Comment Response Letter

Project Name: Hendricks Commons

Project Log Number: DSRFY2023-0009

OPEN SPACE
EXHIBIT

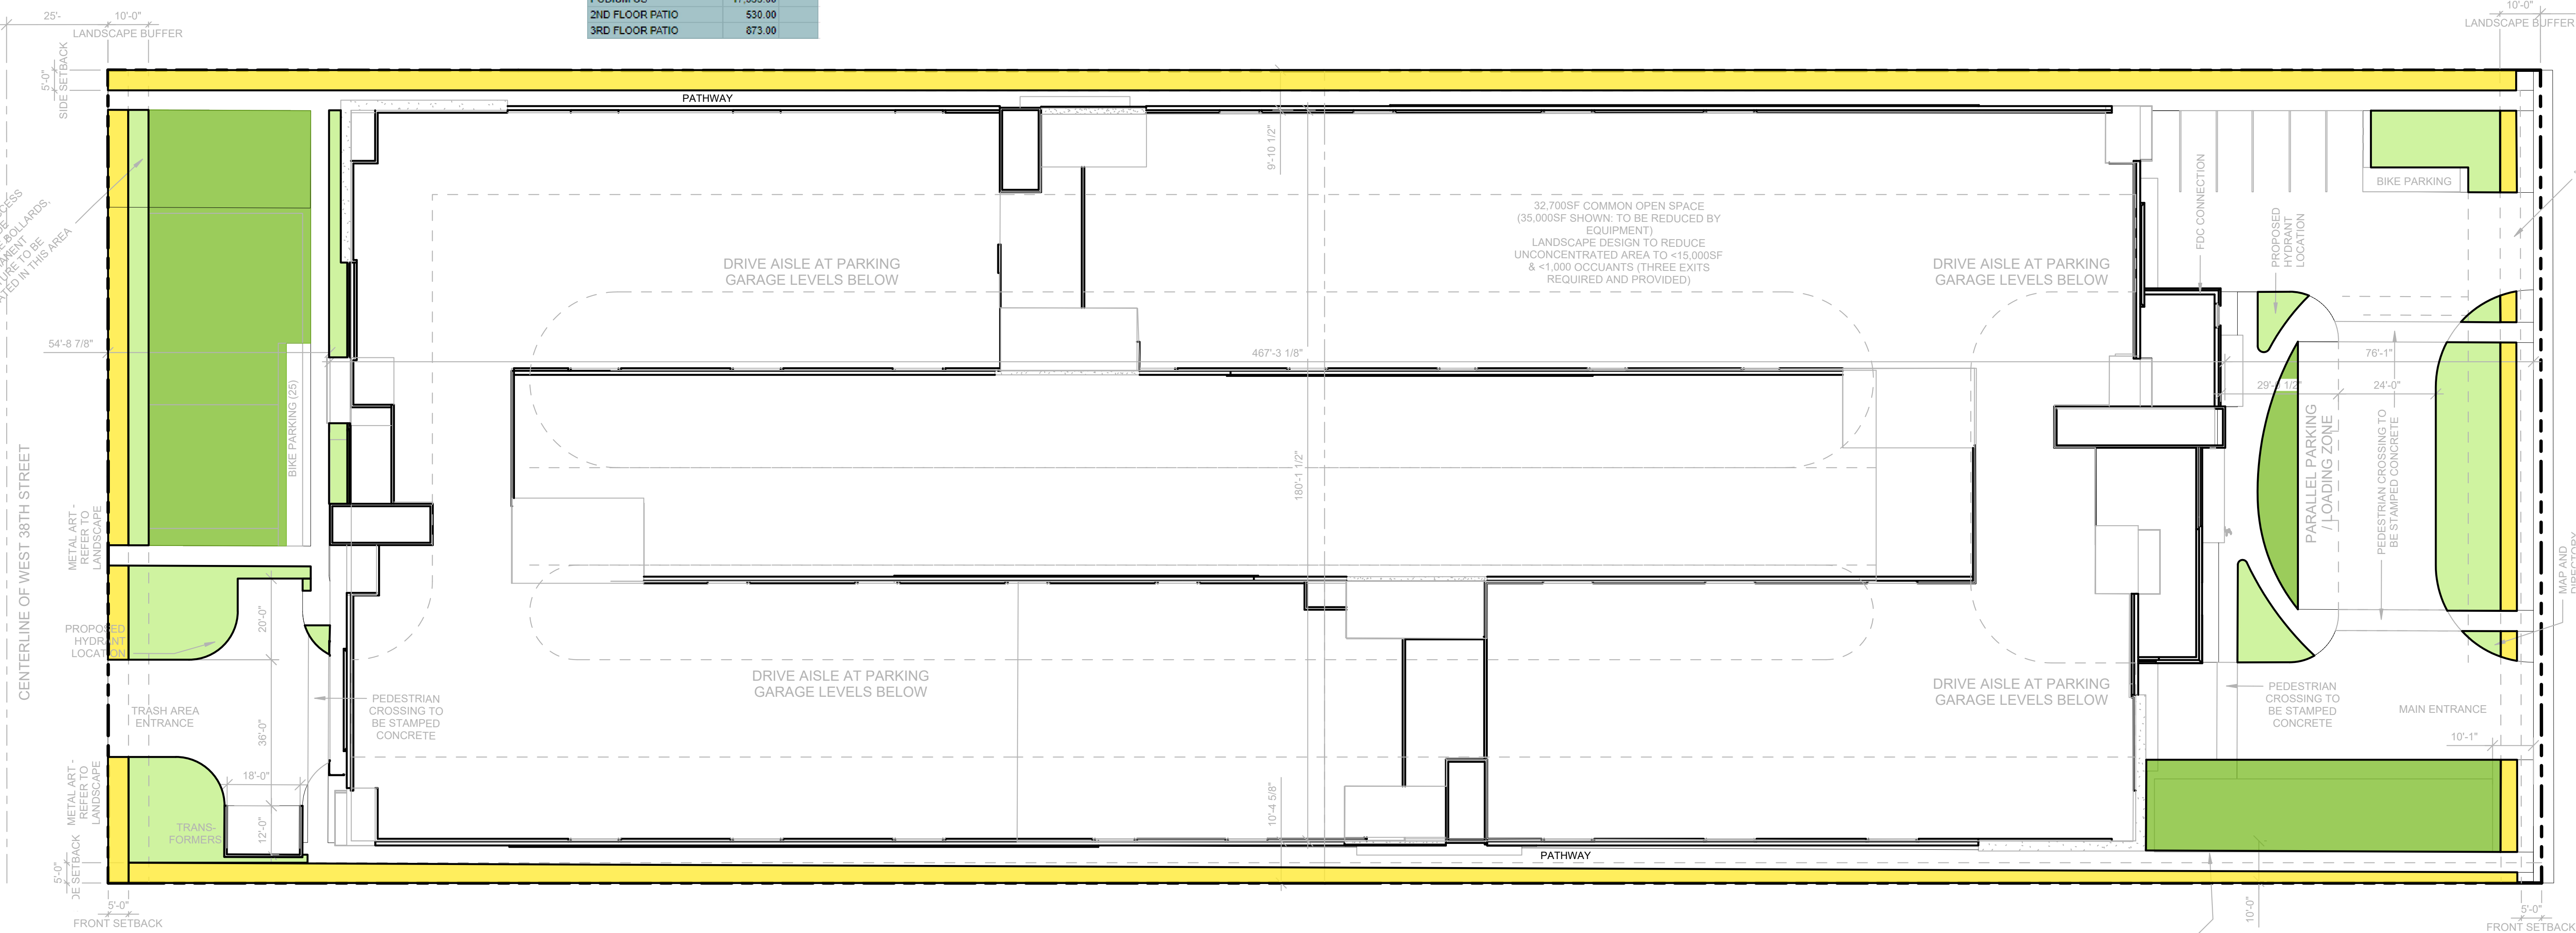
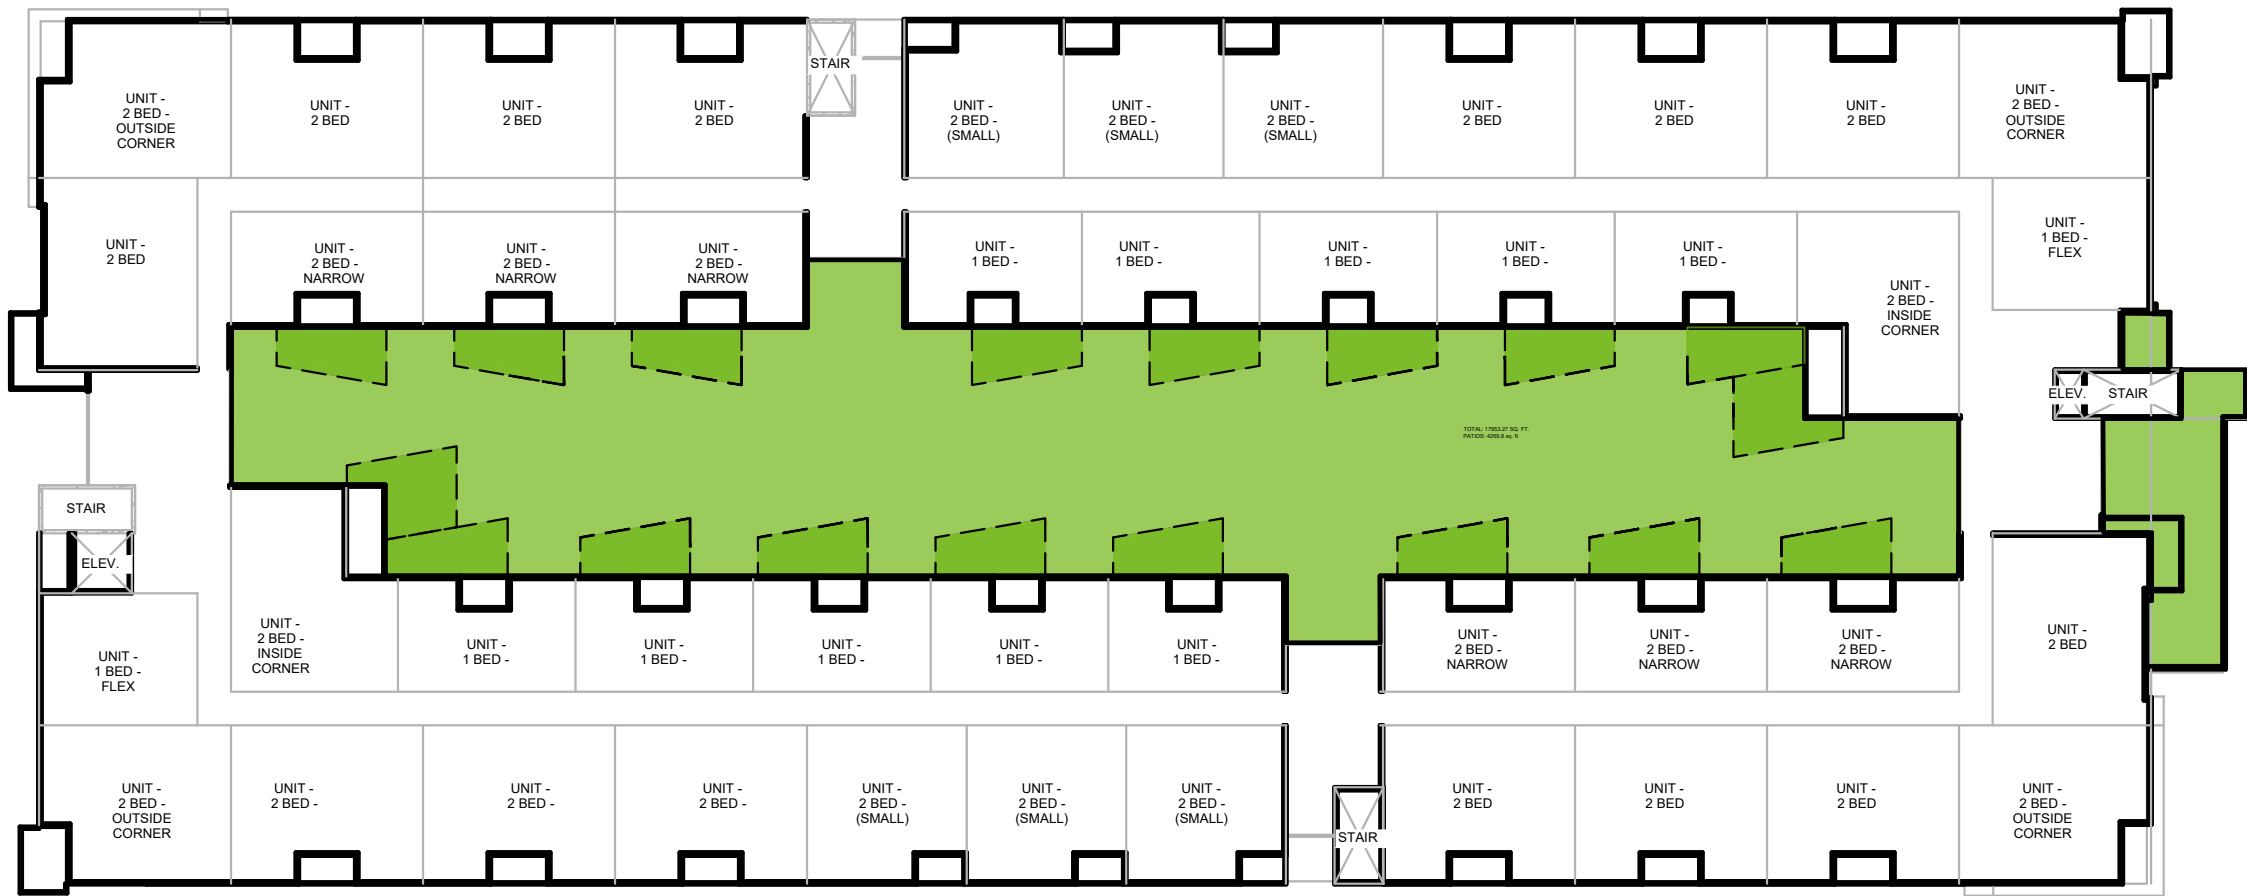
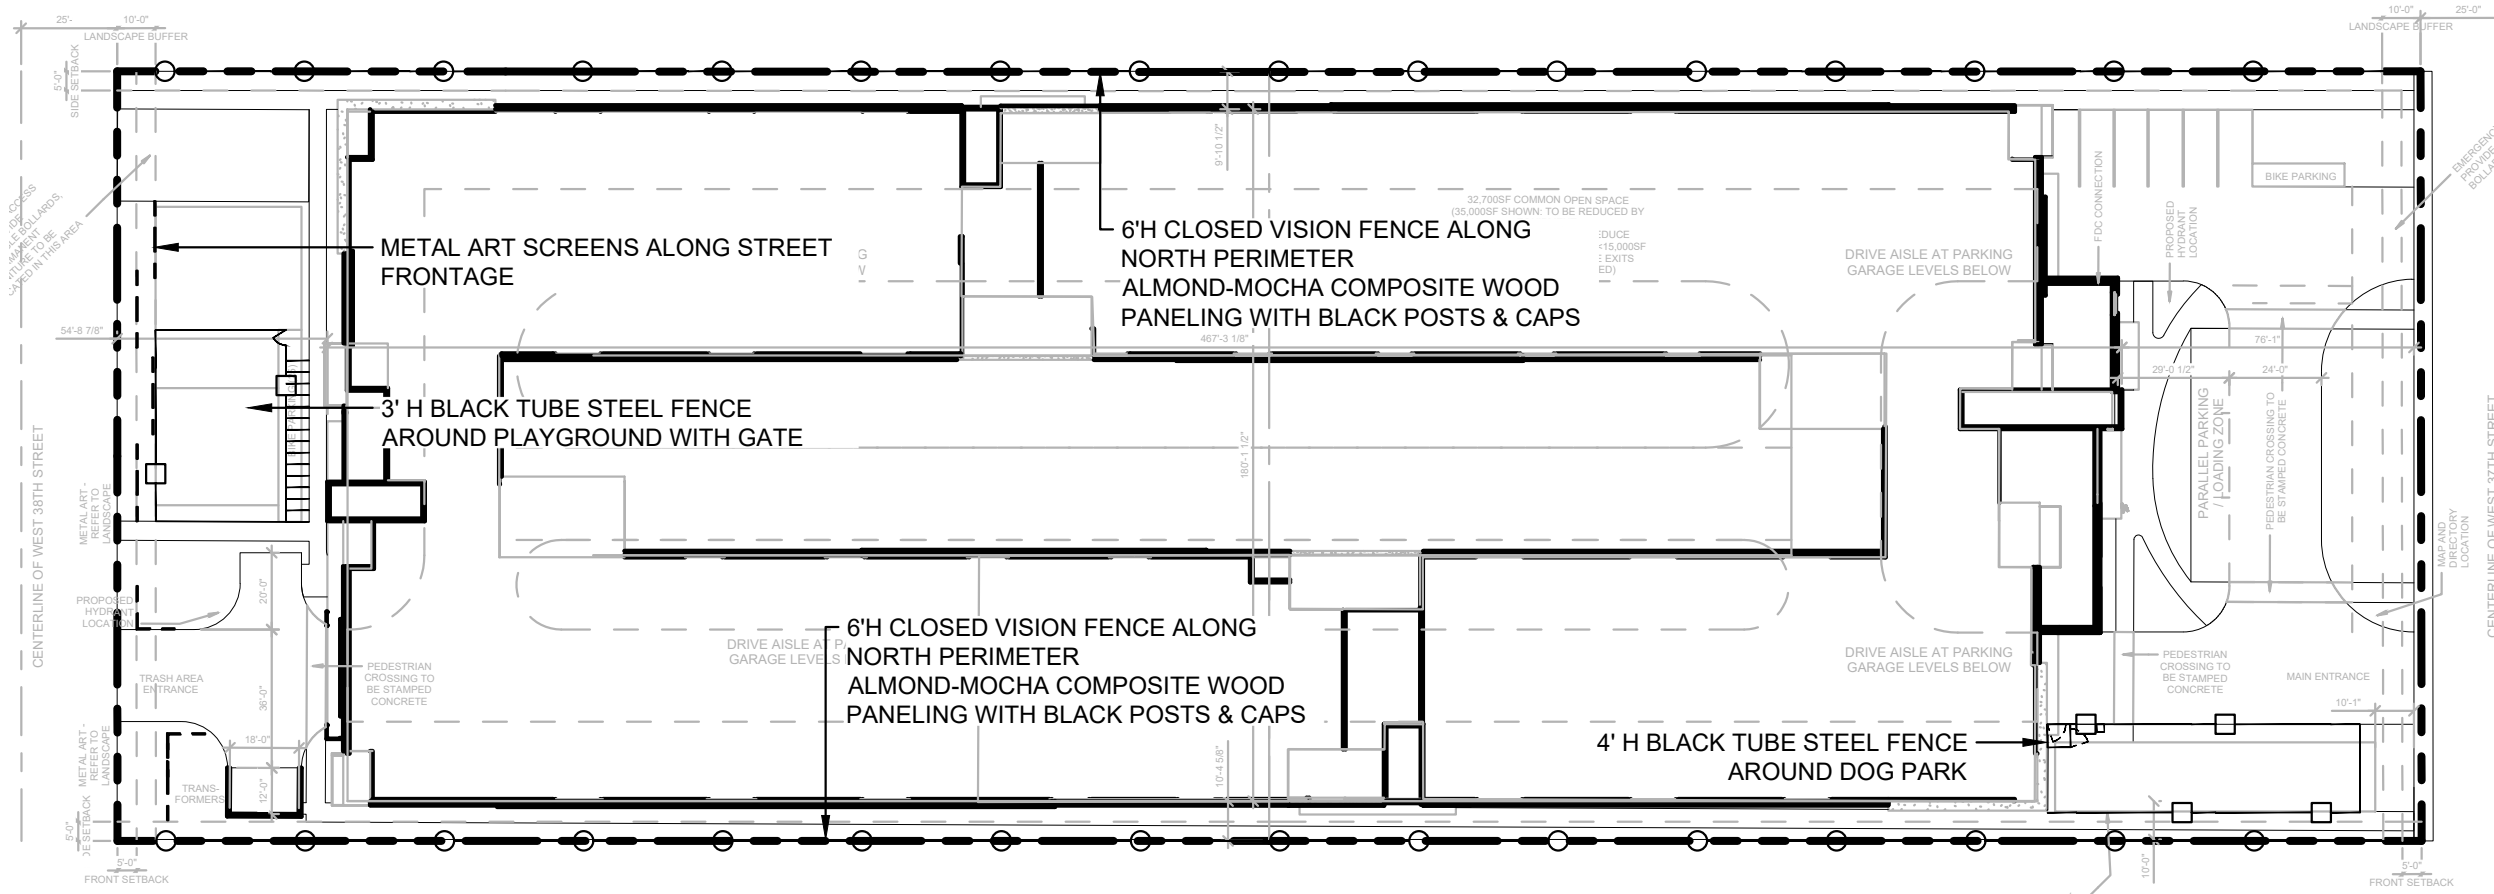
16. Show private & common open space calculations/dimensions.

Response: See updated open space analysis on A100 and L103.

13. 8-4L-3 General Open Space Standards
 - a. Please refer to revised plans sheet A100 and L103 for updated common open space design. Common open space areas are provided with connectivity with other open areas through the vertical circulation in the project, and proposed pathways at the ground level.

- b. Common Open Space:
 - i. Please refer to the revised table on the site plan sheet A100, and revised open space exhibit sheet L103 for updated open space calculations. Required open space calculations are shown below.

LANDSCAPE
IRRIGATION
PLAN

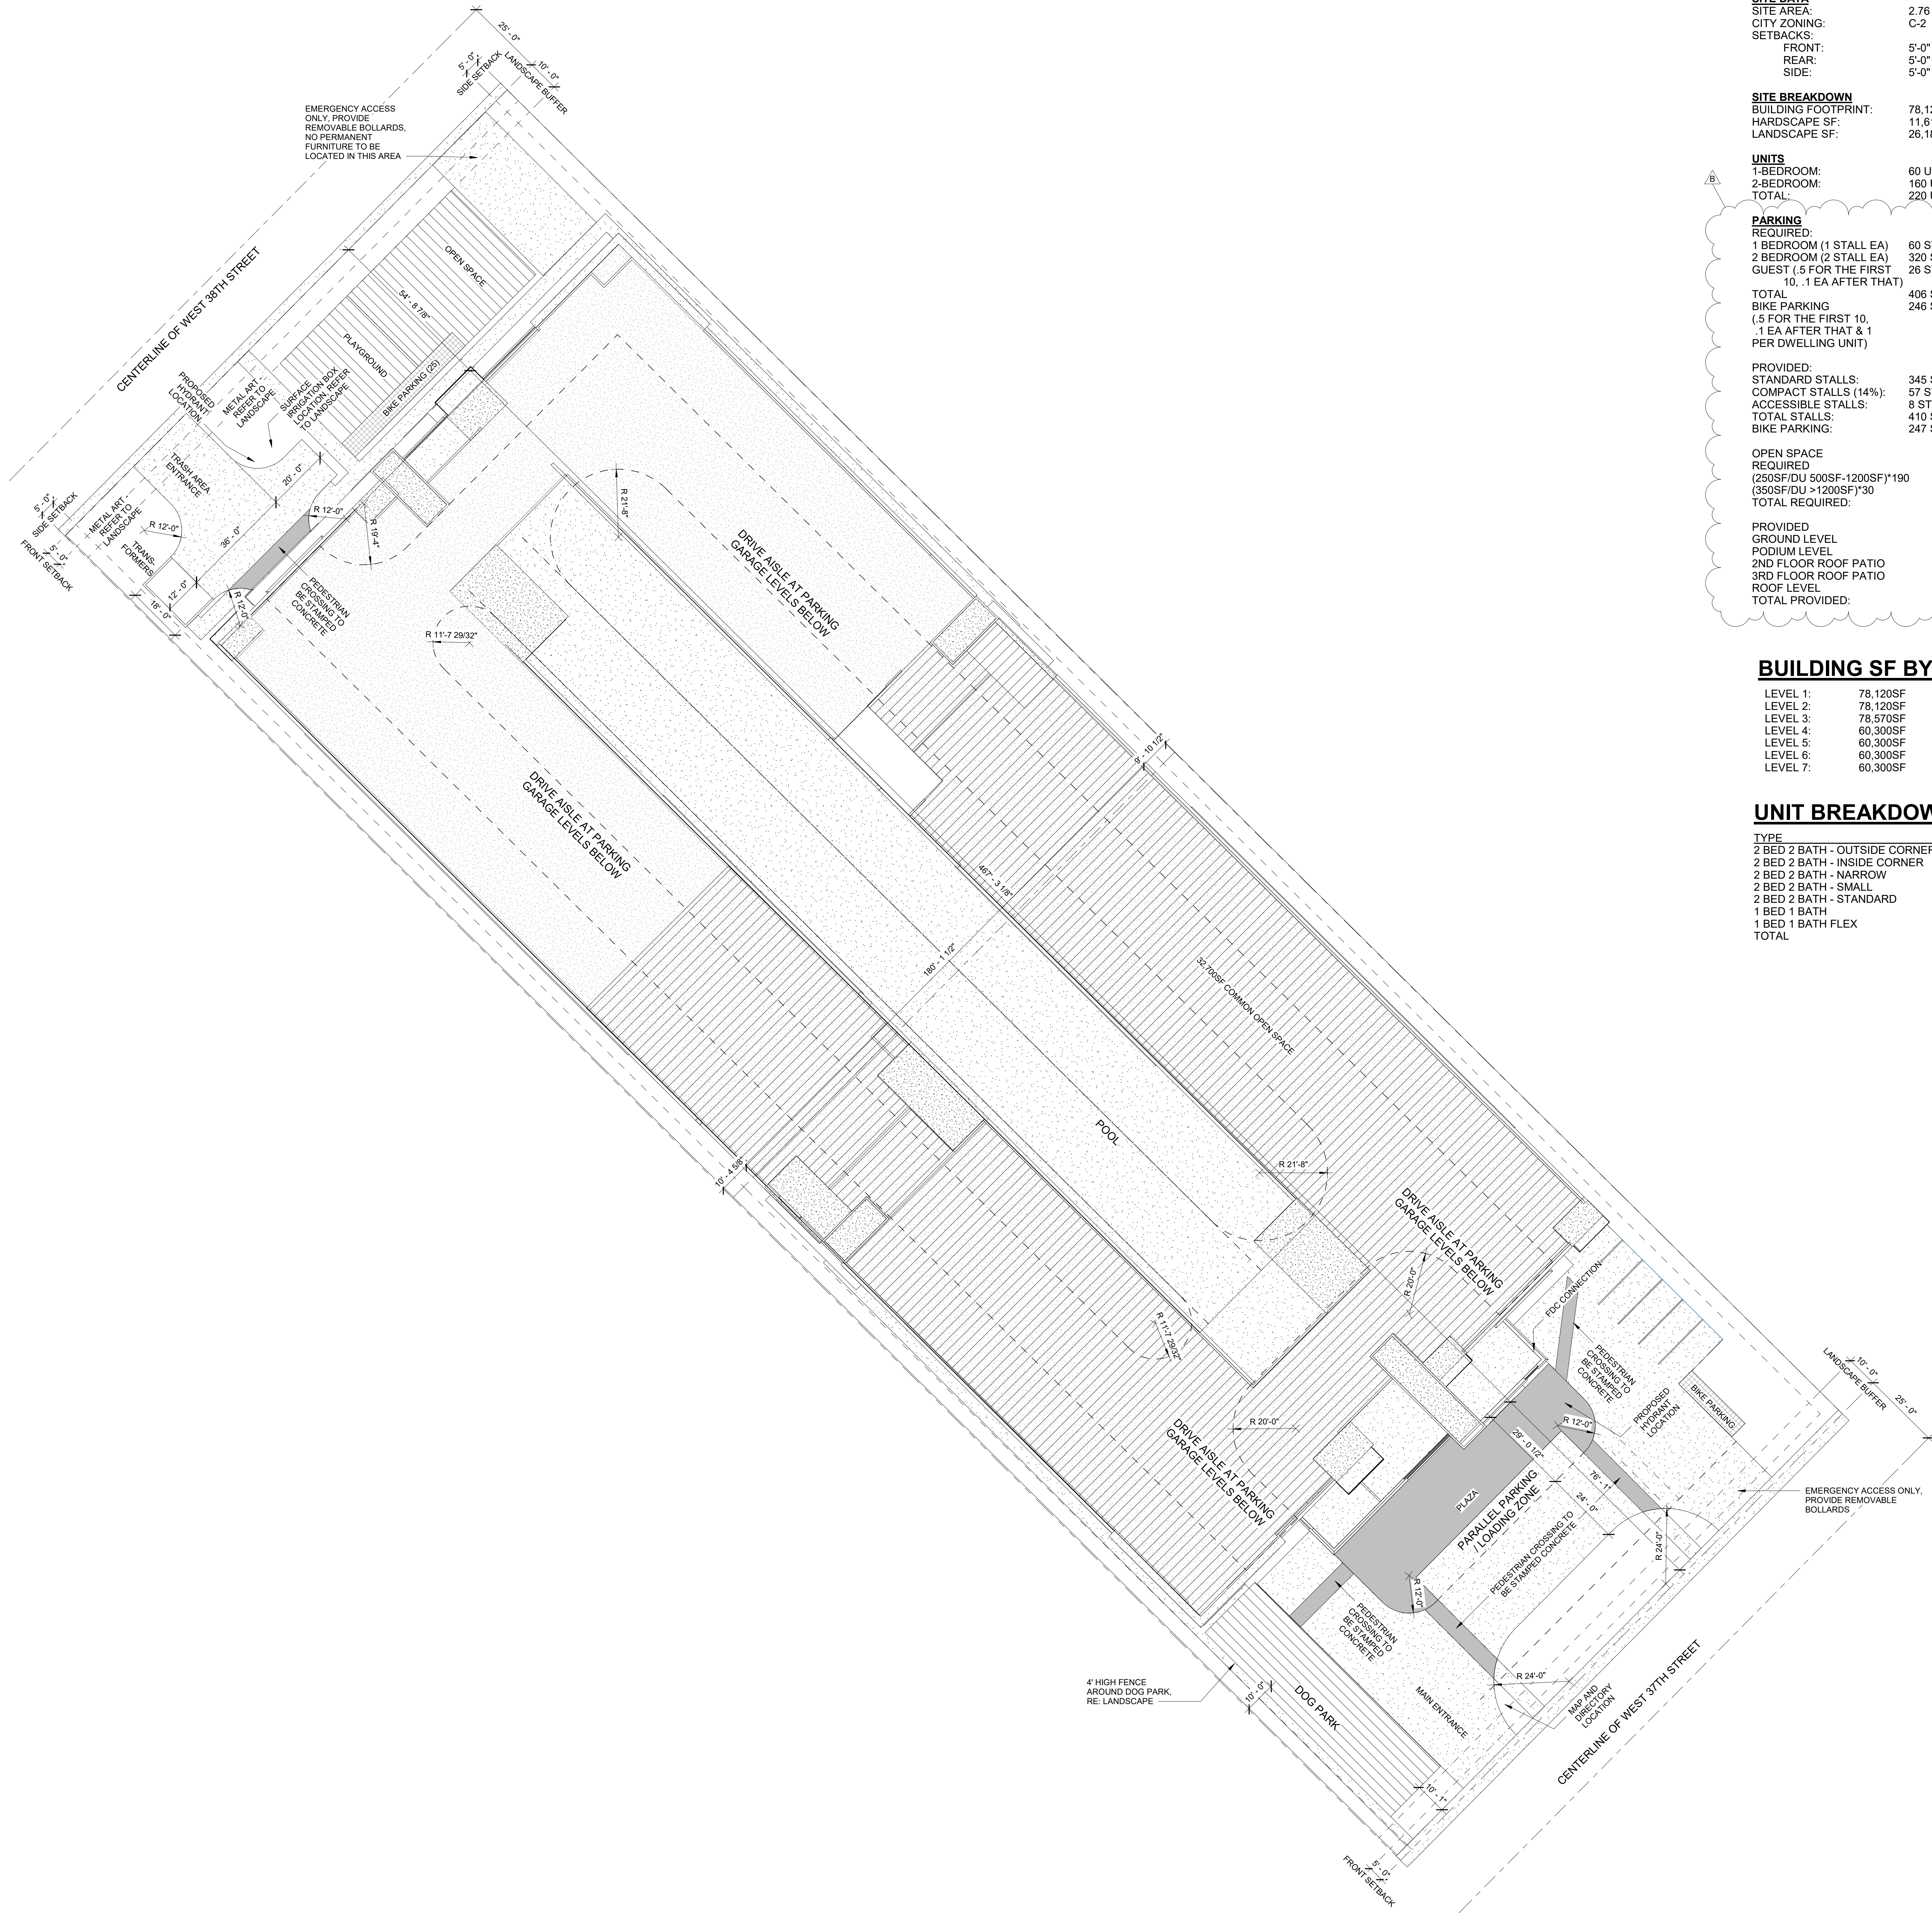
2. There is surface irrigation available on site that should be utilized per Idaho Statute 67-6537. Consider location and footprint on site, and easements.

Response: Surface irrigation will be utilized on site. Irrigation box is located on the west side of the site. See updated irrigation plan sheet L200 in landscape plan and sheet A100 of site plan. Necessary easement will be put in place prior to development of the site to accommodate surface irrigation.
